UNITED STATES PATENT AND TRADEMARK OFFICE

APPLICATION NO.	FILING DATE	FIRST NAMED INVENTOR	ATTORNEY DOCKET NO.	CONFIRMATION NO.
09/531,531	03/21/2000	Yuichi Shiota	257718	7092

Office Action Summary	Application No.	Applicant(s)	
	09/ 531, 531	Shirota et al.	
	Examiner	Art Unit	
	FORD	3743

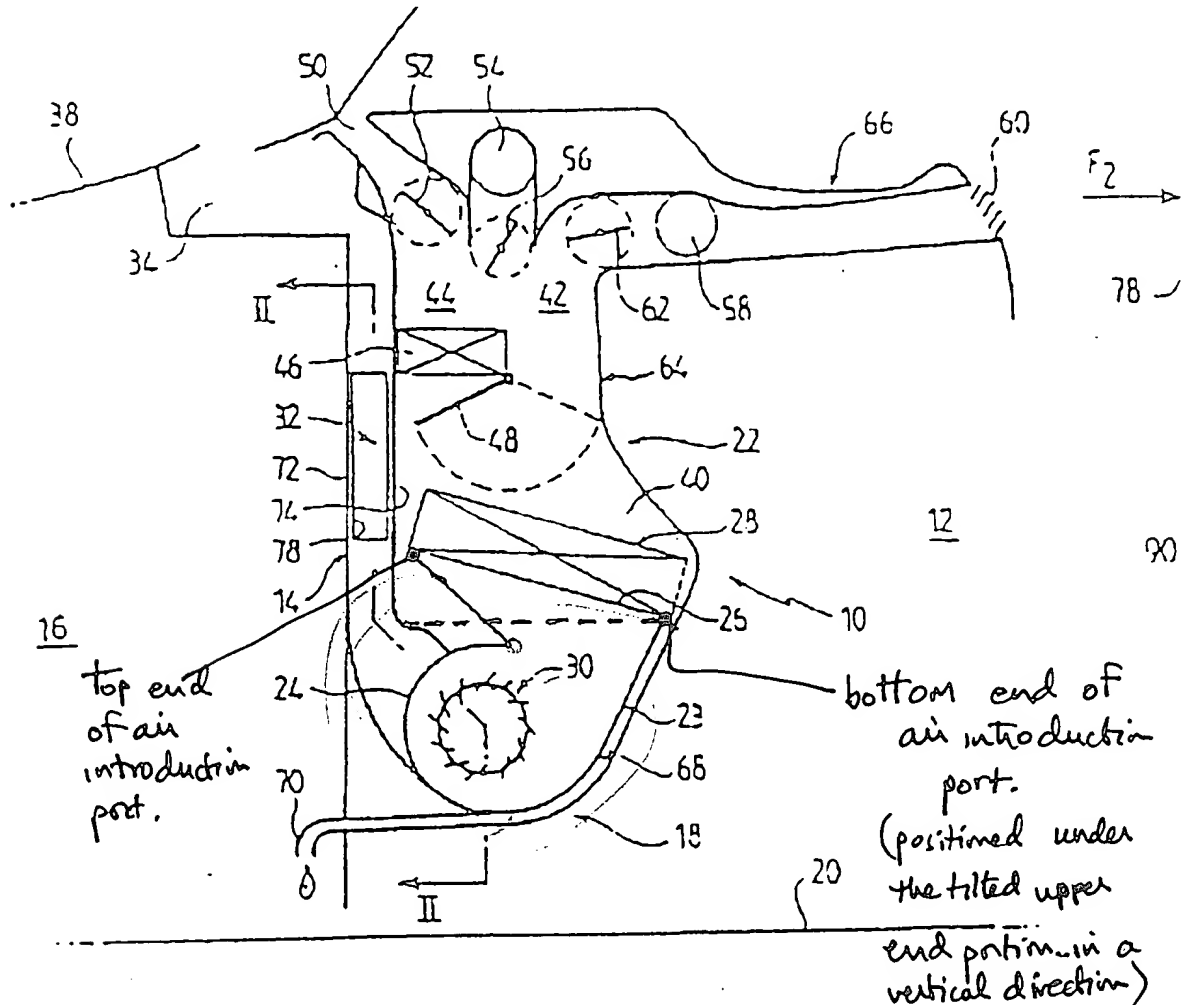
JA'365 (Fig. 50 shows the essential subject matter of claim 6 with the exception of the details of the fins on the evaporator (the evaporator is shown schematically)). Arguably, elements 13 may not be "mode members" as called forth in the claims, but the translation submitted is so abbreviated these elements are not even mentioned. In applicant's response (paragraph bridging pages 13-14 of the June 25, 2001 amendment) translations are discussed but have not been provided. Please provide full translations of JA 5-336 and JA 6-16049 response to this action. This is a repeated request. As well, the top of the fan discharge (23) appears to be slightly below the bottom of the lowest point an evaporator (6) when a horizontal line is drawn across the reference.

Contrary to applicants' statement, however, the bottom end of the air introduction port of JA'365 is clearly positioned under the tilted upper end of the cooling heat exchanger. Also, the Examiner does not know if JA '365 discloses a corrugated fin evaporator because it has not been properly translated. Moreover, Newton discloses the relationship of the air introduction port to cooling heat exchanger notwithstanding applicants' remarks to the contrary.

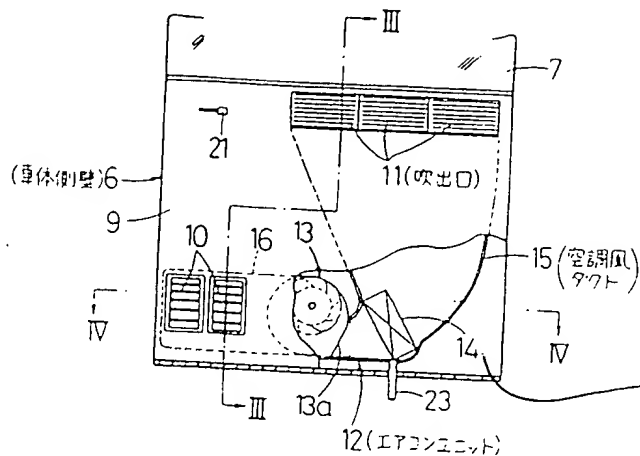
To the extent that is necessary to meet the claim limitation that the bottom end of the air introduction port is vertically below the top end (and not horizontally spaced therefrom as implied, but not explicitly claimed in claim 6) each of Stech, JP 2-17388 (Fig. 4) or JP63-17107 or Newton teach this configuration.

To have moved the evaporator 6 of JA'365 downward towards the bottom of the fan plenum so that the lowest point on the evaporator was below the highest point on the fan discharge aperture (23) to advantageously reduce the overall height of the unit to permit it to fit in smaller vehicles (with less vertical space) would have been obvious. This orientation of fan to evaporator is fairly taught by any one of Stech, JP'388 (Fig. 4) JP 63-17107 or Newton.

Teaching to move
bottom of evaporator
(14) to bottom of
casing (12)

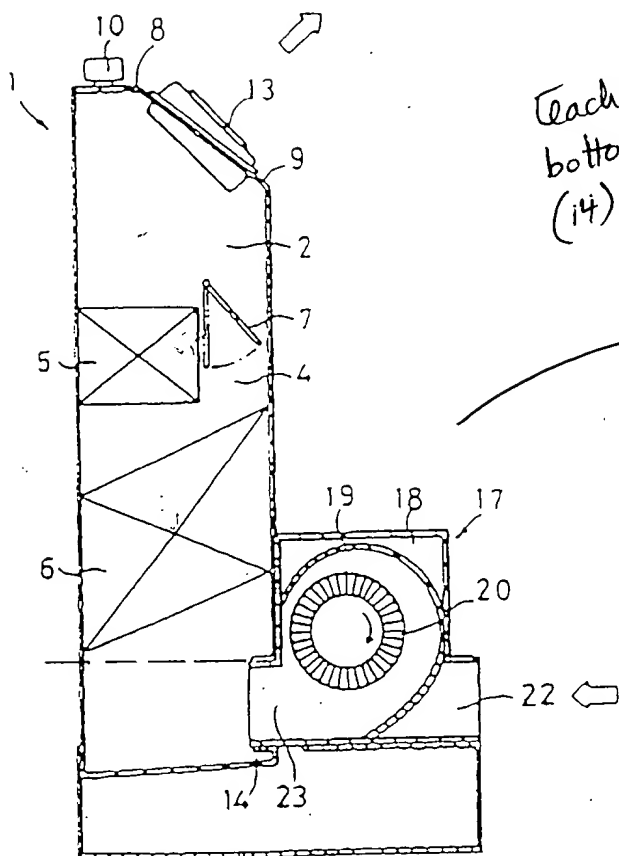
The proposed modification using JP 63-17107 as a teaching reference is illustrated below. Given this example, applicants can see that the same modification would have been obvious from any of the teachings of Stech, JP'388 (Figure 4) or Newton in the alternative. JA'107, however, is the simplest reference to understand and is used here for purpose of illustration. See next page.

第 5 図

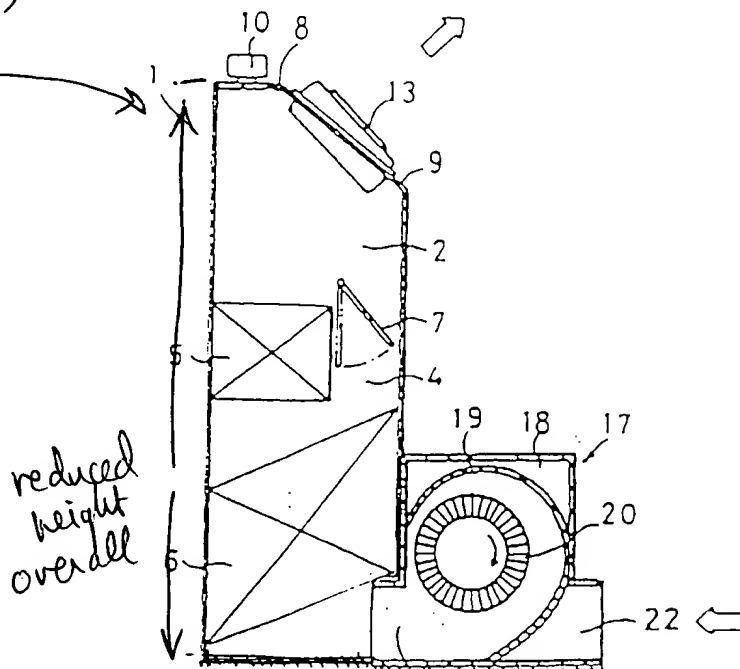
evaporator lowered to
advantageously reduce overall
height of the HVAC unit
